USB Port Change Part

Change list

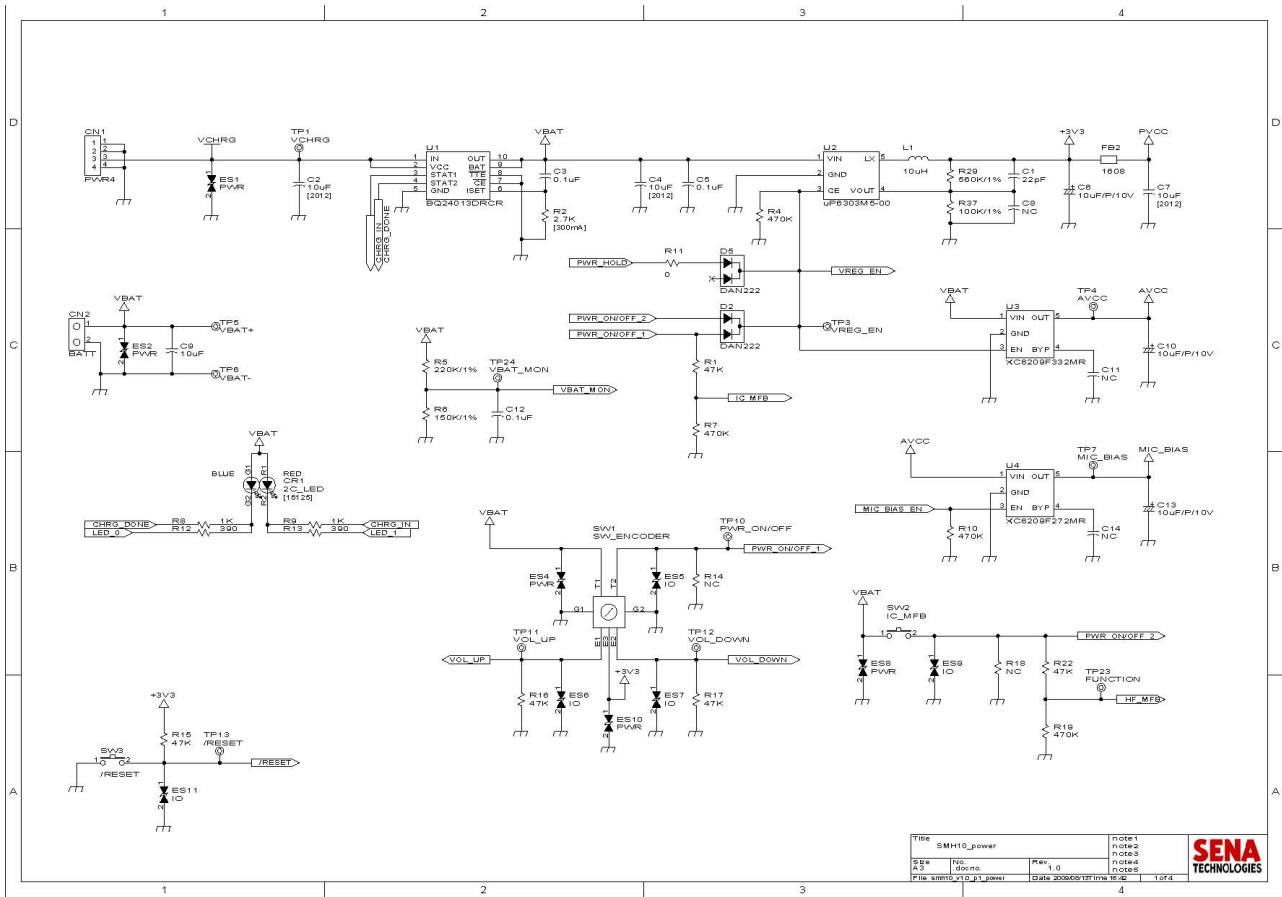
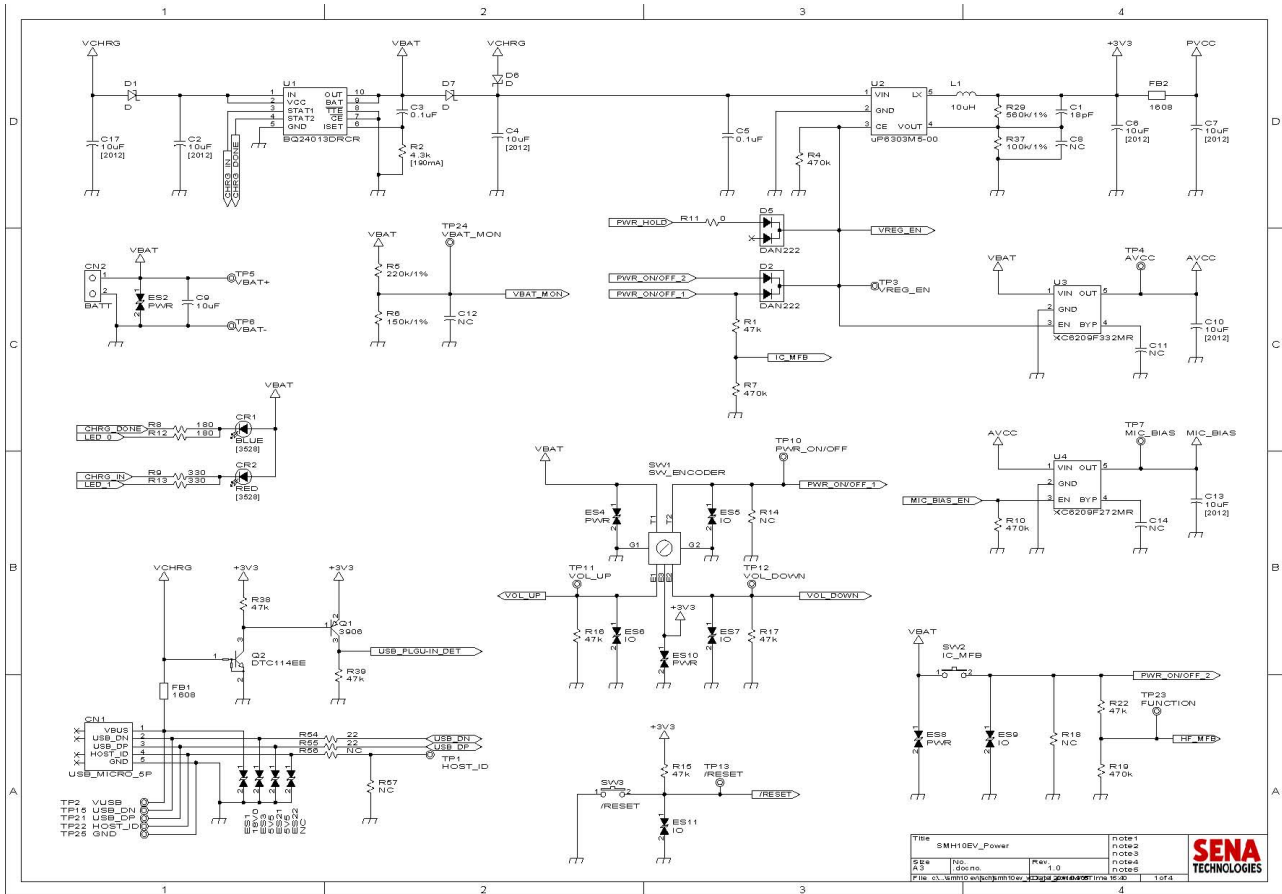
Item	before	after	비고
DIODE	-	D6,D7	ADD
Micro USB 5P	DC POWER JACK (CN1)	CN1	CHANGE
BEAD	-	FB1	ADD
NPN TR	-	Q2	ADD
PNP TR	-	Q1	ADD
RESISTANCE	-	R38, R39, R54, R55, R53	ADD
CONDENSER	-	C26, C27, C17	ADD
LED(BLUE)	DUAL LED	CR1	CHANGE
LED(RED)	DUAL LED	CR2	CHANGE

Internal Photo

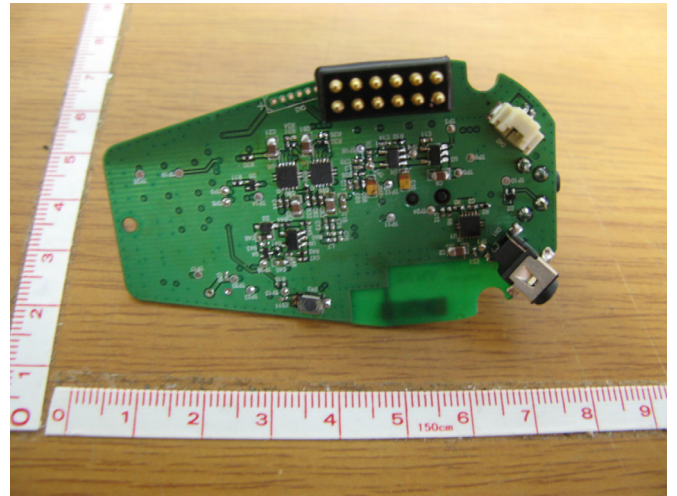
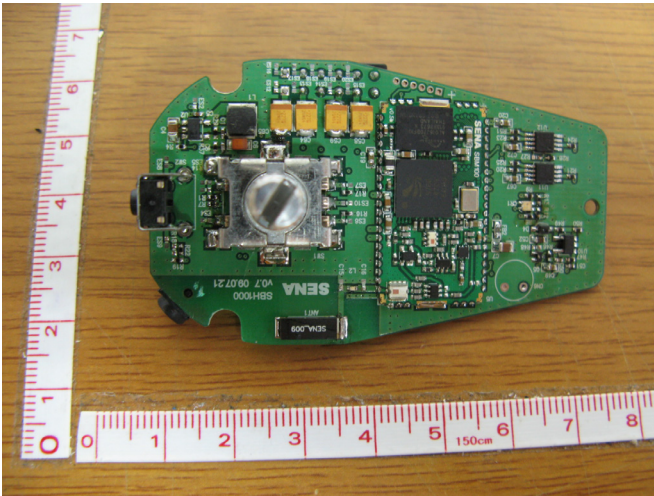
Before

After
